# UNITED STATES PATENT AND TRADEMARK OFFICE

APPLICATION NO.	FILING DATE	FIRST NAMED INVENTOR	ATTORNEY DOCKET NO.	CONFIRMATION NO.
10/714,191	11/14/2003	John Fritsch	12-9540-6520-0000-1	9356

## Office Action Summary

### US-5,779,411 to Vasseur et al.

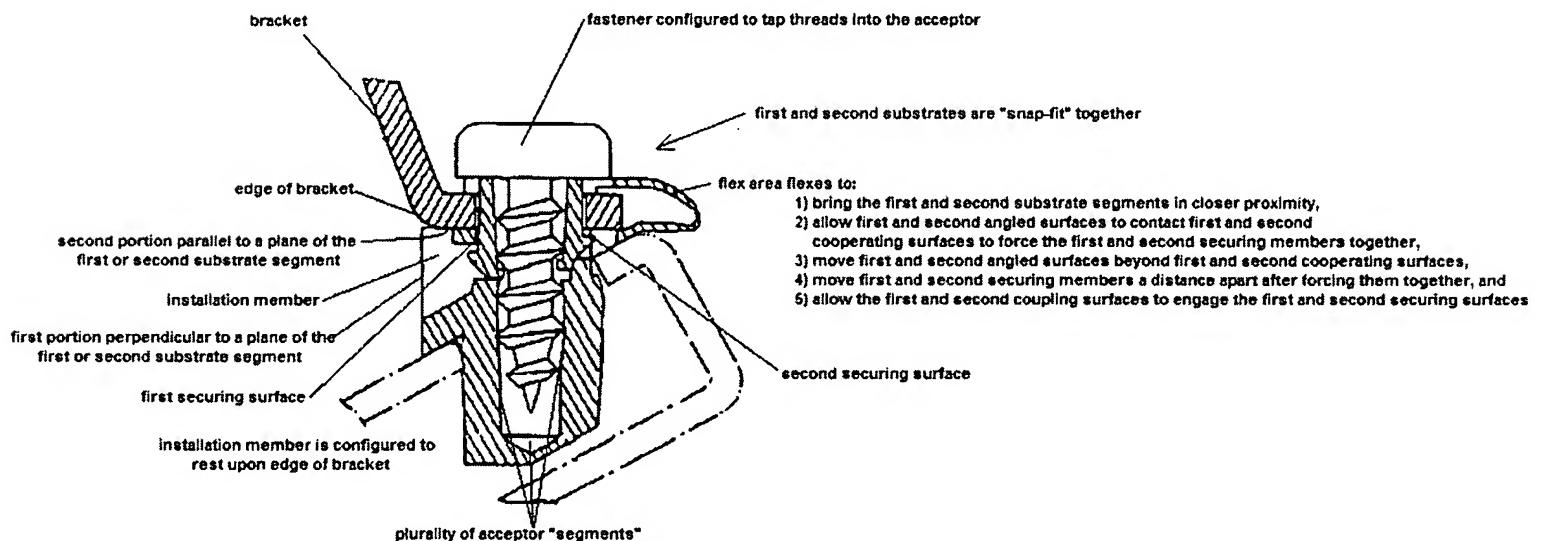
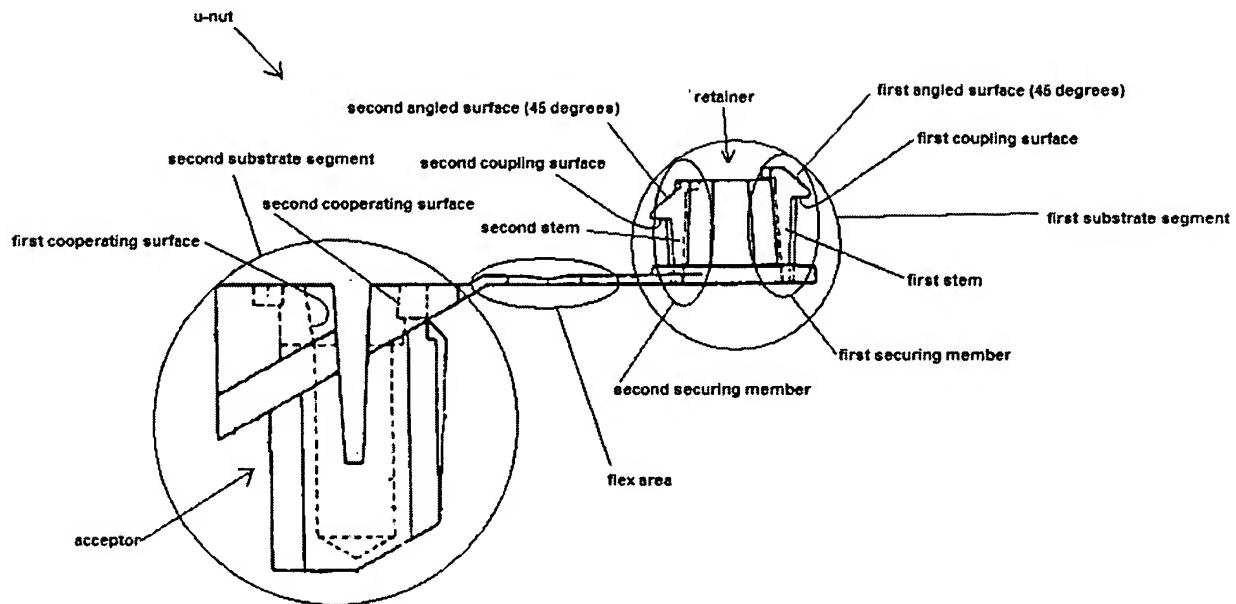
[7] Claims 1-20 are rejected under 35 U.S.C. 102(b) as being anticipated by Vasseur et al. US-5,779,411.

In short, Vasseur et al. teach a U-nut (1) having a flex area (3), first substrate segment (2), and second substrate segment (4). The first substrate segment has a retainer comprising a first securing member (22) and second securing member (24) -- each having a stem (22,24), angled 45° surface (26,27), and coupling surface (28,29). The second substrate segment (4) has an acceptor (16) having first and second cooperating surfaces (8,11) and first and second securing surfaces (16). The first and second securing members are snap fit within the acceptor (abstract lines 1-2). The U-nut may comprise a fastener (15) configured to "tap threads into the acceptor" (col. 3 lines 35-38) so as to provide a clamping force. The U-nut has what could broadly be construed as an "installation member" (7,10,13) that is "configured to" (i.e., capable of) "resting upon an edge of a bracket (40,50). Note that any portions of the acceptor could be broadly construed as "a plurality of acceptor segments".
